## **RESOLUTION AGREEMENT**

Westminster College  
OCR Docket Number 07102031

**Compliance Chart**  
Westminster College, Fulton, Missouri  
OCR Docket #07102031

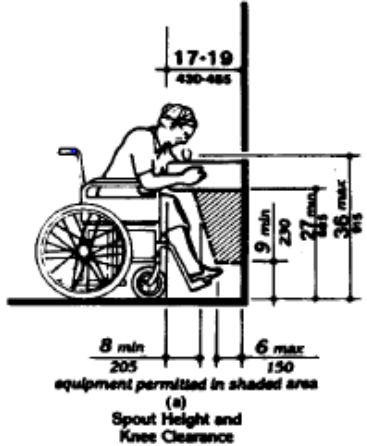
Location Surveyed: Westminster Hall	Uniform Federal Accessibility Standards (UFAS) <sup>2</sup> (unless noted otherwise)	Existing Measurements or Summary of Non-compliance	Photographs, if Available (enlarge electronically)	Remedial Action <sup>3</sup> UFAS Standards (unless noted otherwise)
	<p>4.27: Controls: Clear floor space complying with 4.2.4 that allows a forward or a parallel approach by a person using a wheelchair shall be provided at controls and other operable equipment. 4.27.2. See also, 4.27.3 (Height) and 4.27.4 (Operation) of controls.</p> <p>Anti-discrimination standards: 34 C.F.R. §§ 104.4 and 104.21.</p>	<p>Curb ramps and ramps on existing sites may have slopes and rises complying with Table 2 in 4.1.6 if space limitations prohibit the use of a 1:12 slope or less.</p>	 <p>View of lift near the entrance.</p>	
<p><b>Accessible route to the back entrance of Westminster Hall</b></p>	<p>Existing facility standards (34 C.F.R. §§ 104.21 and 104.22)</p> <p>Anti-discrimination standards (34 C.F.R. § 104.4)</p> <p>Guidance: Accessible Route: 4.3</p> <p>4.3.2(1): At least one accessible route within the boundary of the site shall be provided from public transportation stops, accessible parking, and accessible passenger zones, and public streets or sidewalks to the accessible building entrance they serve.</p> <p>4.3.2(2): At least one accessible route shall connect accessible buildings, facilities, elements, and spaces that are on the same site.</p> <p>See also 4.3.3-4.3.10.</p>	<p>The designated accessible route between the front and back entrance should comply with 4.3, including 4.3.3 (width), 4.3.4 (passing space), 4.3.5 (head room), 4.3.6 (surface textures), 4.3.7 (slope), 4.3.8 (changes in levels) and 4.3.9 (doors) requirements.</p>	 <p>Aerial view of Westminster Hall grounds, including sidewalks, drive behind Westminster Hall, and part of horseshoe drive.</p>	<p>Ensure there is an accessible route that complies with 4.3, including width, slope, and changes in level requirements, that connects the front and back accessible Westminster Hall entrances. 4.3.</p>

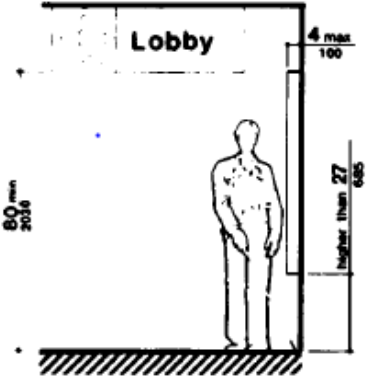
Location Surveyed: Champ Auditorium	Uniform Federal Accessibility Standards (UFAS) (unless noted otherwise)	Existing Measurements or Summary of Non-compliance	Photographs, if Available (enlarge electronically )	Remedial Action UFAS Standards (unless noted otherwise)
<p><b>Champ Auditorium</b></p> <p><b>North entrance doors (exterior and interior)</b></p>	<p>Existing facility standards (34 C.F.R. §§ 104.21 and 104.22)</p> <p>Anti-discrimination standards (34 C.F.R. § 104.4)</p> <p>Doors: 4.1.1(7) and 4.13:</p> <p>4.13.5: Doorways shall have a minimum clear opening of 32” with the door open 90 degrees, measured between the face of the door and the stop.</p> <p>4.13.11: The maximum force for pushing or pulling open an interior hinged door is 5 lbs. No opening force is specified for exterior doors.</p> <p>4.1.1(7)(c): All signs shall comply with 4.30. Accessible entrances shall be identified with the international symbol of accessibility.</p>	<p>Each independently operated exterior door’s opening was less than 32”.</p> <p>The opening force for both doors is 6-8 lbs. While there are no specific UFAS standards for maximum door opening force for exterior hinged doors, an opening force up to 8 lbs. for the exterior doors significantly exceeds the 5 lb. maximum force considered suitable for people with disabilities with respect to interior hinged doors. See 4.13.11.</p> <p>There is no sign with the international symbol of accessibility for the north entrance door.</p> <p>The opening force of the interior door leading to the auditorium was 11 lbs.</p>	 <p>Designated accessible north entrance doors at the bottom of the ramp landing.</p>	<p>Ensure at least one of the exterior door leaves has a 32” clear opening width and appropriate maneuvering space.</p> <p>Install an automatic door opener for the exterior door at the bottom of the ramp in accordance with 4.13.12. While there is no specific opening force standard in UFAS for an exterior hinged door, the existing opening force could exclude individuals with disabilities from accessing the lower level of the building, contrary to 34 C.F.R. § 104.4 (Section 504 general anti-discrimination provisions) and 34 C.F.R. § 104.21 (Section 504 anti-discrimination provision regarding accessibility).</p> <p>Adjust interior door leading to auditorium so the maximum opening force is 5 lbs. Check all interior doors for complying opening force.</p> <p>Install a sign with the international symbol of accessibility for the north entrance door and provide directional signage to the accessible north entrance for auditorium access.</p>

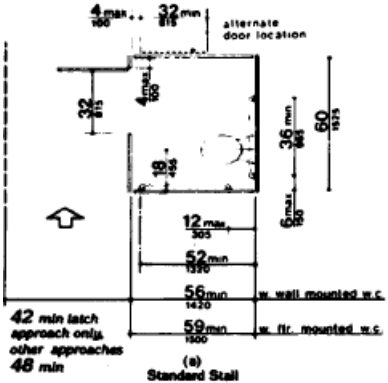
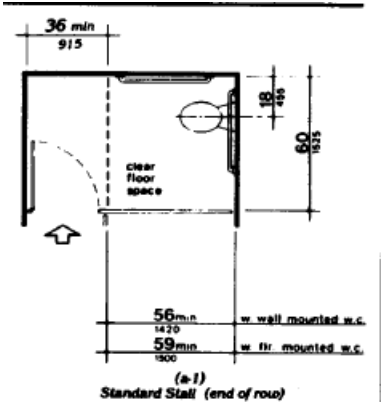
Location Surveyed: Church & Museum	Uniform Federal Accessibility Standards (UFAS) (unless noted otherwise)	Existing Measurements or Summary of Non-compliance	Photographs, if Available (enlarge electronically)	Remedial Action UFAS Standards (unless noted otherwise)
	<p>4.13.4: Double-Leaf Doorways: If doorways have two independently operated door leaves, then at least one leaf shall meet the specifications in 4.13.5 and 4.13.6. That leaf shall be an active leaf.</p> <p>4.13.5: Clear Width: Doorways shall have a minimum clear opening of 32" with the door open 90 degrees, measured between the face of the door and the stop.</p> <p>4.13.7: Two Doors in Series: The minimum space between two hinged or pivoted doors in series shall be 48" plus the width of any door swinging into the space. Doors in series shall swing either in the same direction or away from the space between the doors (see Fig. 26).</p> <p>4.13.8: Threshold: Thresholds at doorways shall not exceed .75" in height for exterior sliding doors or .5" for other types of doors. Raised thresholds and floor level changes at accessible doorways shall be beveled with a slope no greater than 1:2.</p> <p>4.13.9: Door Hardware: Handles, pulls, latches, locks, and other operating devices on accessible doors shall have a shape that is easy to grasp with one hand and does not require tight grasping, tight pinching, or twisting of the wrist to operate. Hardware must be mounted no higher than 48" above the floor.</p>		 <p>Designated accessible entrance with doors open.</p>  <p>Threshold in front of outside door at north accessible entrance.</p>	 <p>Fig. 26: Two hinged doors in series, swinging away from space.</p> <p>Ensure the entrance is connected by an accessible route.</p>

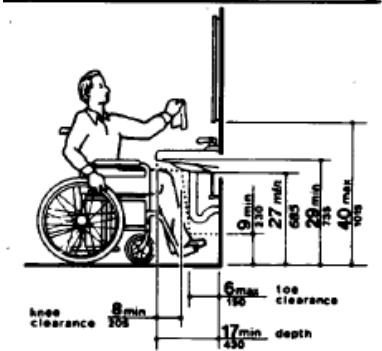
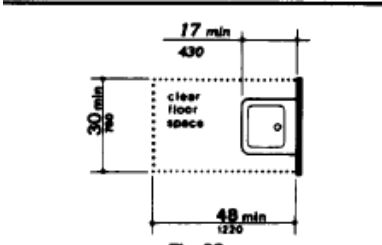
Location Surveyed: Church & Museum	Uniform Federal Accessibility Standards (UFAS) (unless noted otherwise)	Existing Measurements or Summary of Non-compliance	Photographs, if Available (enlarge electronically)	Remedial Action UFAS Standards (unless noted otherwise)
<b>Museum Lift</b>	<p><u>Platform Lifts: 4.11</u></p> <p>4.11.3: Unassisted entry/exit: If a platform lift is used, the lift should facilitate unassisted entry and exit from the lift.</p> <p>4.5.1: Floor Surfaces: Ground and floor surfaces along accessible routes and in accessible rooms and spaces, including floors, walks, ramps, stairs, and curb ramps, shall be stable, firm, slip-resistant, and shall comply with 4.5.</p> <p>4.27: Controls: Clear floor space complying with 4.2.4 that allows a forward or a parallel approach by a person using a wheelchair shall be provided at controls and other operable equipment. 4.27.2. See also, 4.27.3 (Height) and 4.27.4 (Operation) of controls.</p> <p>Section 504 regulation: 34 C.F.R. §§ 104.4(a) (Anti-discrimination provision).</p>	<p>The Museum lift cannot be operated independently; a Museum staff member must assist an individual with a disability to use the lift.</p> <p>The non-slip material is torn in places.</p>	 <p>Museum lift near entrance.</p>	<p>Ensure the lift can be used and operated independently by an individual with a disability, including entering and exiting the lift without assistance, or provide OCR with a plan for providing a lift that can be operated independently.</p> <p>Ensure the lift complies with 4.11.2, including 4.2.4, 4.5, 4.27, and repair any torn non-slip material on the lift surface.</p>

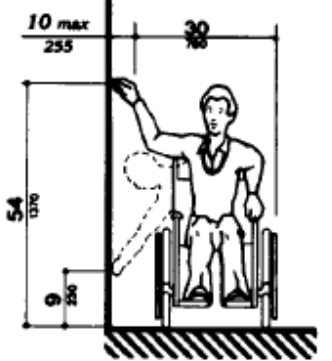
Location Surveyed: Church & Museum	Uniform Federal Accessibility Standards (UFAS) (unless noted otherwise)	Existing Measurements or Summary of Non-compliance	Photographs, if Available (enlarge electronically)	Remedial Action UFAS Standards (unless noted otherwise)
	<p>stall is greater than 60", then the toe clearance is not required.</p> <p>4.17.5: Doors: Toilet stall doors shall comply with 4.13. If toilet stall approach is from the latch side of the stall door, clearance between the door side of the stall and any obstruction may be reduced to a minimum of 42".</p> <p>4.17.5/4.13.5: Clear Width: Doorways shall have a min. clear opening of 32" with the door open 90 degrees, measured between the face of the door and the stop (see Fig. 24(a)-(d)). Openings more than 24" in depth shall comply with 4.2.1 (clear floor/ground space; 30"x48") and 4.3.3 (min. clear width of an accessible route; 36")</p> <p>4.17.5/4.13.6 (Fig. 25): Minimum maneuvering clearances at doors that are not automatic or power-assisted shall be as shown in Fig. 25. The floor or ground area within the required clearances shall be level and clear.</p> <p>4.13.9: Door Hardware</p> <p>4.17.6: Grab bars: Grab bars shall comply with 4.26 and the length and positioning shall comply with Fig. 30(a)-(c).</p>			 <p>Fig. 30(a): A standard toilet stall, above.</p>  <p>Fig. 30(a-1): A standard toilet stall at the end of a row.</p>

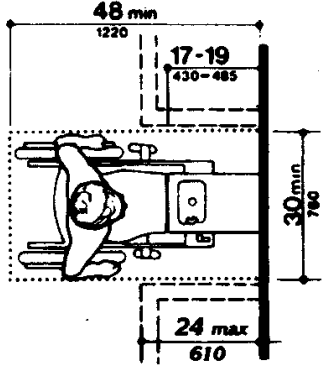
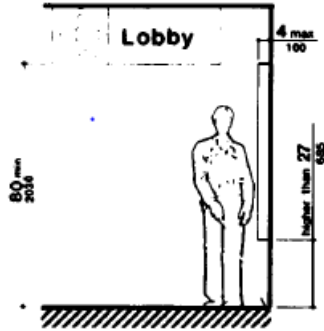
Location Surveyed: Church & Museum	Uniform Federal Accessibility Standards (UFAS) (unless noted otherwise)	Existing Measurements or Summary of Non-compliance	Photographs, if Available (enlarge electronically)	Remedial Action UFAS Standards (unless noted otherwise)
	<p>4.17.5/4.13.5: Clear Width: Doorways shall have a min. clear opening of 32" with the door open 90 degrees, measured between the face of the door and the stop (see Fig. 24(a)-(d)). Openings more than 24" in depth shall comply with 4.2.1 (clear floor/ground space; 30"x48") and 4.3.3 (min. clear width of an accessible route; 36")</p> <p>4.17.5/4.13.6 (Fig. 25): Minimum maneuvering clearances at doors that are not automatic or power-assisted shall be as shown in Fig. 25. The floor or ground area within the required clearances shall be level and clear.</p> <p>4.17.6: Grab bars: Grab bars shall comply with 4.26 and the length and positioning shall comply with Fig. 30(a)-(c).</p>			 <p>Fig. 30(a-1): A standard toilet stall at the end of a row.</p>  <p>Fig. 30(c): Grab bar height and width on rear wall of a standard stall.</p>
